Model: Model L1b		Date: 30-Oct-02	No.: RH911001
Subject: Printer & Scanner Drivers Type 1100		Prepared by: A. Ishiyama	
From: Technical Services Sec., Service Planning Dept.			
Classification:	<input checked="" type="checkbox"/> Troubleshooting <input type="checkbox"/> Mechanical <input type="checkbox"/> Paper path <input type="checkbox"/> Other (      )	<input type="checkbox"/> Part information <input type="checkbox"/> Electrical <input type="checkbox"/> Transmit/receive	<input type="checkbox"/> Action required <input type="checkbox"/> Service manual revision <input type="checkbox"/> Retrofit information

Model: Model L1		Date: 1-Nov-02	No.: RH911002
Subject: Service Manual & Parts Catalog Correction		Prepared by: A. Ishiyama	
From: Technical Services Sec., Service Planning Dept.			
Classification:	<input type="checkbox"/> Troubleshooting <input type="checkbox"/> Part information <input type="checkbox"/> Action required <input type="checkbox"/> Mechanical <input type="checkbox"/> Electrical <input checked="" type="checkbox"/> Service manual revision <input type="checkbox"/> Paper path <input type="checkbox"/> Transmit/receive <input type="checkbox"/> Retrofit information <input ty

Image samples appear on the following pages (written to simulate actual handwritten styles).

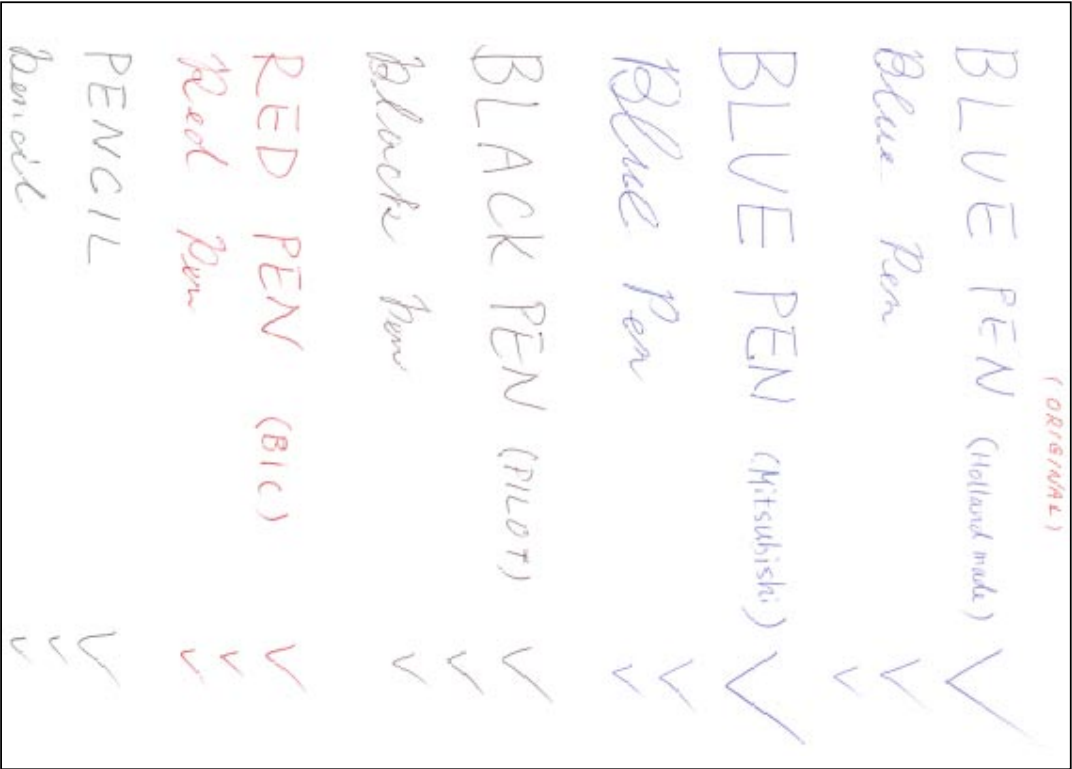
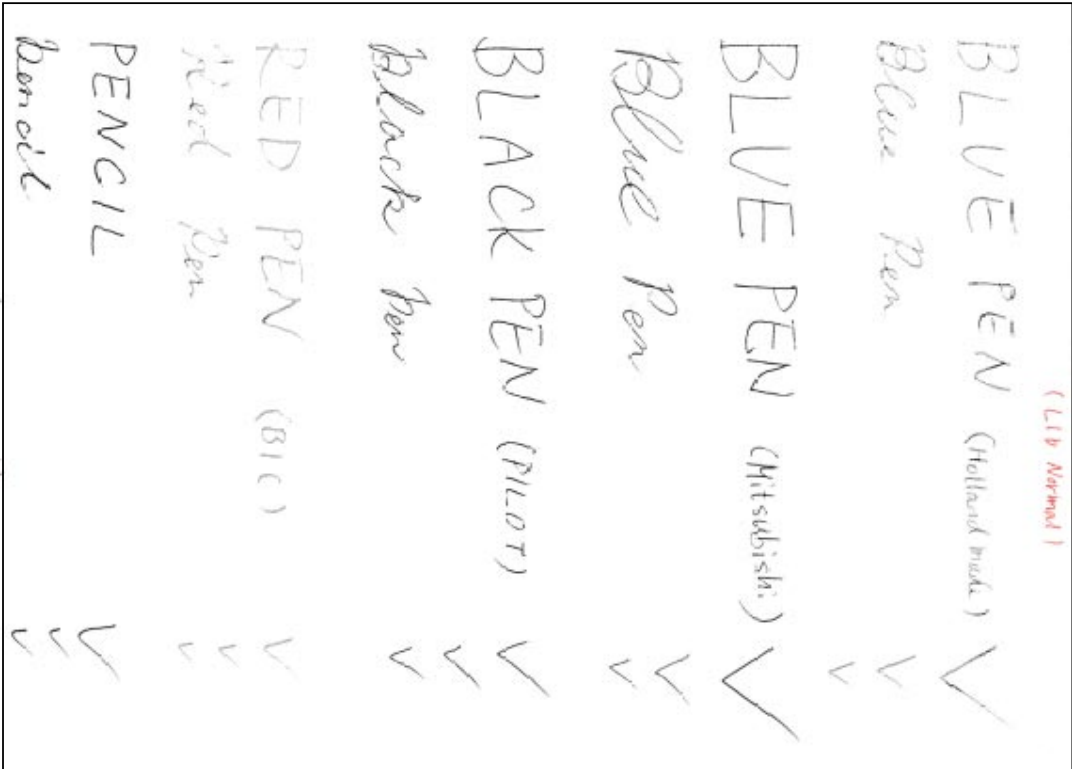
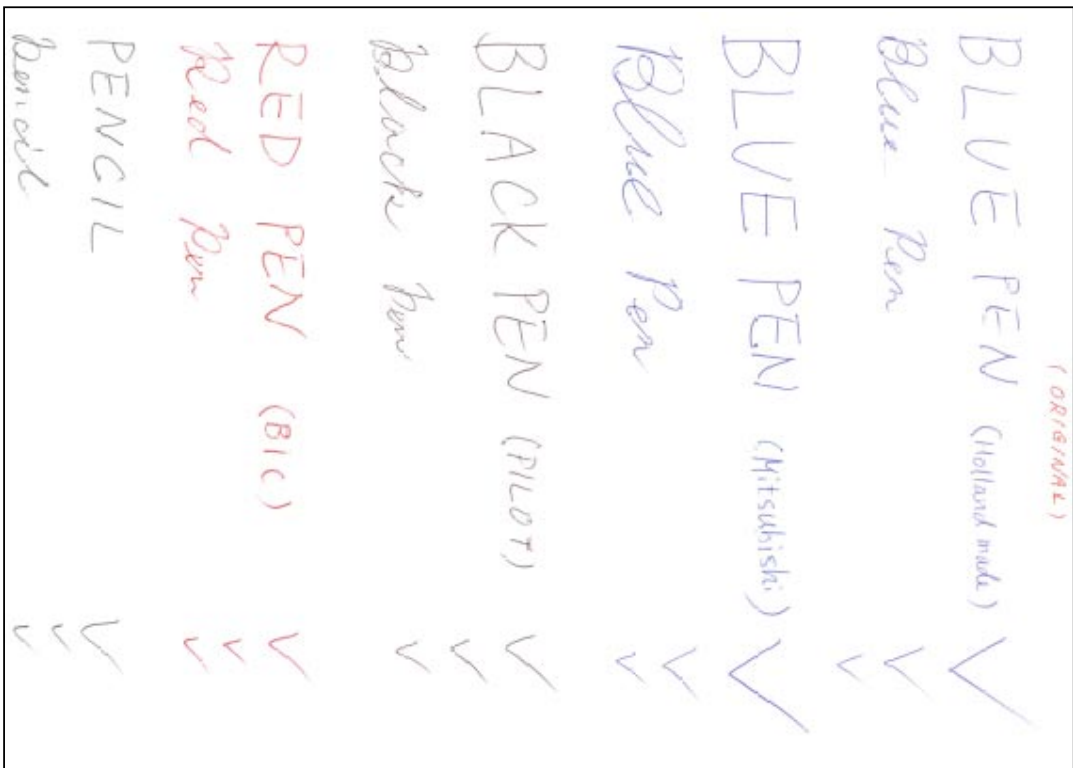
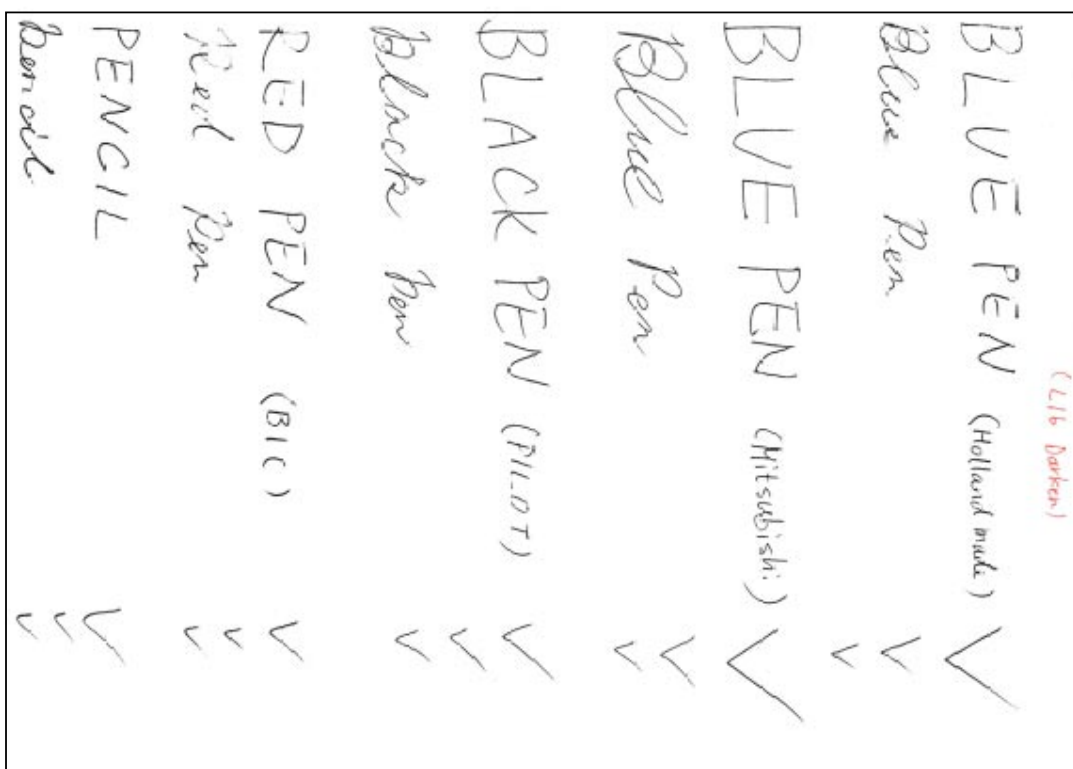
Poor reproduction of some areas written with a blue ballpoint pen.

The CIS (contact image sensor) in H912 models use blue light for exposure, which can make it difficult to reproduce some blue areas written in pen on the original. As shown on the following pages, some manufacturers produce pens that do not appear well on outputs.

**Note:** The CIS in H911 models and in most Ricoh fax products employs yellow-green light for exposure, which has no trouble in reproducing areas hand written in blue pen.

Use the "Darken" setting on the operation panel when sending or making copies of an original containing areas hand-written in blue pen.

### 4.5.16 TREMBLING AT THE END WHEN OHP PRINTING

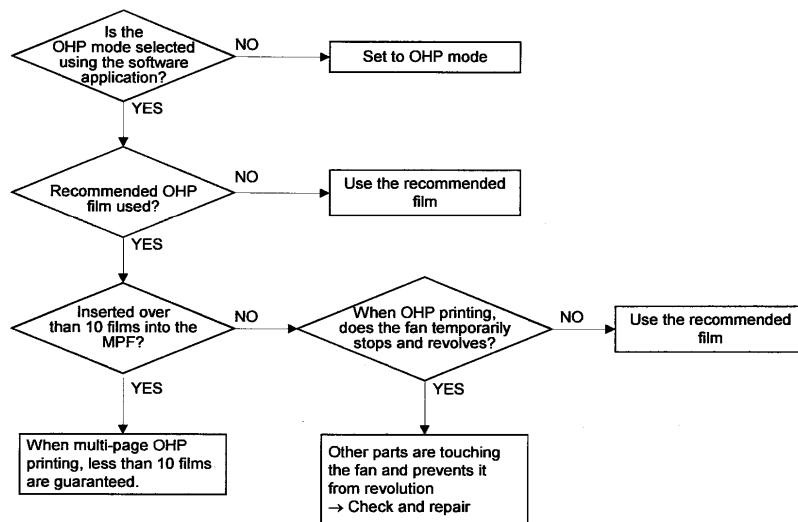
No.	Section	Page	Reason for Revision	
			General Correction	Addition for Asia
1	PRECAUTIONS	1	Yes	
2	TABLE OF CONTENTS	ii ~ iii	Yes	
3	3.13 TOP COVER	3-11	Yes	
4	3.15 LSU	3-12	Yes	
5	4.5.8 GHOST	4-13	Yes	
6	4.5.10 HORIZONTAL BAND	4-15	Yes	
7	4.5.16 TREMBLING AT THE END WHEN OHP PRINTING	4-19	Yes	
8	4.5.18 NO POWER	4-20	Yes	
<b>9</b>	<b><i>4.5.19 FUSING UNIT ERROR</i></b>	<b><i>4-21</i></b>	<b>Yes</b>	<b>Yes</b>
10	5.1.2 SYSTEM DATA LIST IN TECH MODE	5-2	Yes	Yes
11	5.1.3 TECH MODE OPTIONS	5-3 5-4	Yes	
12	5.2.1 DOWNLOAD PROCEDURE	5-12	Yes	
13	5.2.2 RE-PROGRAMMING PROCEDURE AFTER DOWNLOAD	5-13	Yes	
14	SPECIFICATIONS	Spec-1 Spec-4		Yes
15	PARTS CATALOG	Total 10 pages		Yes
<b>16</b>	<b><i>4.5.17 POOR FUSING GRADE</i></b>	<b><i>4-19</i></b>	<b>Yes</b>	<b>Yes</b>
